CAMERON BALLOONS LTD

SERVICE BULLETIN: SB11

Subject: **A-type Envelopes**

Title: **Inspection of 'Lens' panel to 'Top' panel seam.**

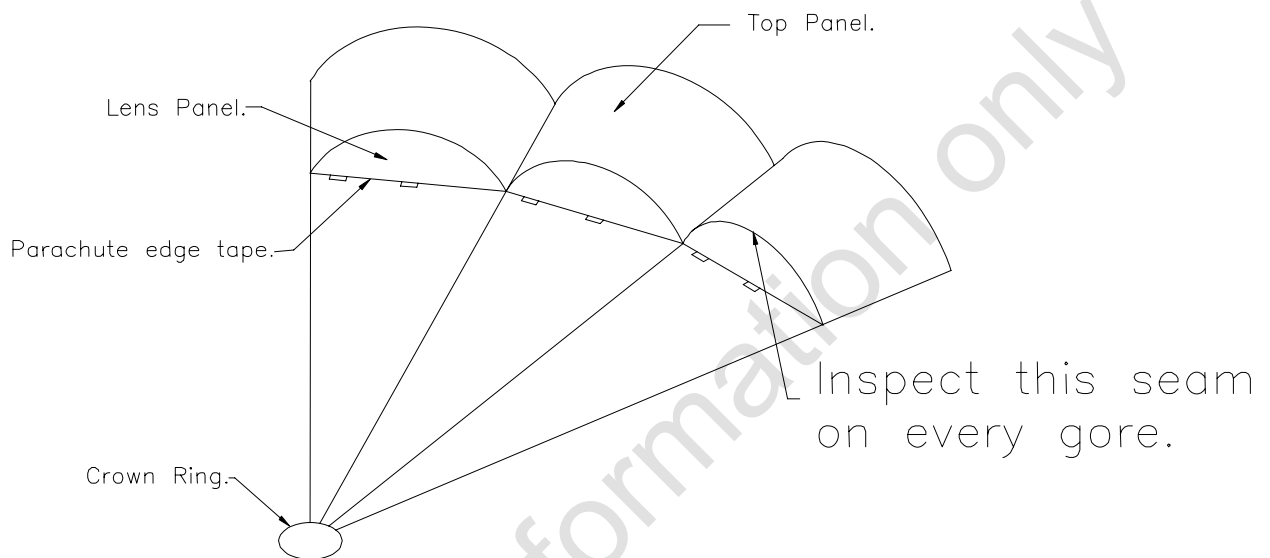
Accomplishment Instructions: **Inspect the envelope as described in section A.**

Unpack the balloon and locate the Crown Ring. Then carefully inspect the inside and outside of the seam indicated below for signs of unpicking.

1. If no damage evident to both rows of stitching, then make the following log book entry :-

2. If less than 2" (50mm) of damaged stitching is evident, this is acceptable until the next scheduled inspection, when any damaged stitching must be repaired in accordance with Section B of this Service Bulletin.
3. The seam must be repaired before further flight if any of the following apply
 - a) Both rows of stitching completely broken.
 - b) More than 2" (50mm) of either row of stitching completely broken.
 - c) Two or more sections of damage between vertical load tapes, where each section has less than 2" (50mm) of either row of stitching completely broken.
